EB-2022-0156 Selwyn Community Expansion Project

Supplementary Interrogatories of Environmental Defence

Interrogatory # 3.0-ED-29

Interrogatory # 3.0-ED-30

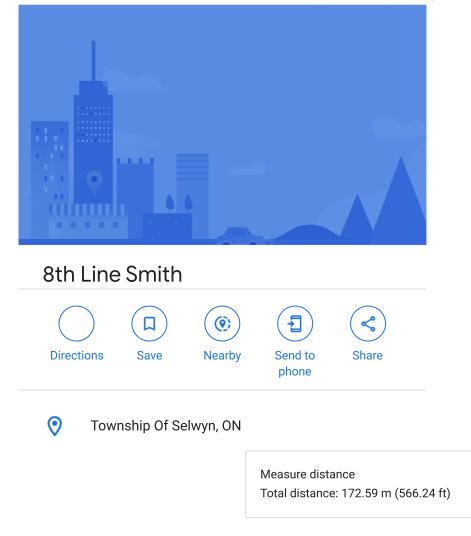
As an illustration of the rural nature of the project area, the following image from Google Maps shows a residence in the project area that is roughly 170 metres from the road. The attached images provide further examples.

- (c) Please provide a table showing, for all the buildings in the project area, the *approximate* length of service line that will be required. If Enbridge does not have that information, please obtain it on an approximate basis using mapping tools. The list does not need to use addresses. Please use simplifying assumptions if Enbridge wishes to do so (e.g. that the service line will run in a straight line from the edge of the shoulder to the nearest point on the house). [Note that this should not be onerous, and Environmental Defence would complete the task if it was permitted to submit evidence. We tested this task with Google Maps, and we were able to record measurements of approximately 5 buildings per minute.]

(e) Please explain how Enbridge determines the length for the purpose of calculating the Extra Length Charge. For instance, is the length measured from the actual gas main, or from some other point (e.g. the edge of the road or the edge of the shoulder)? For customers on the opposite side of the road as the main, do they or Enbridge cover the incremental costs of getting the service line underneath the road? Is this pipe going to run on the north or south side of the road?
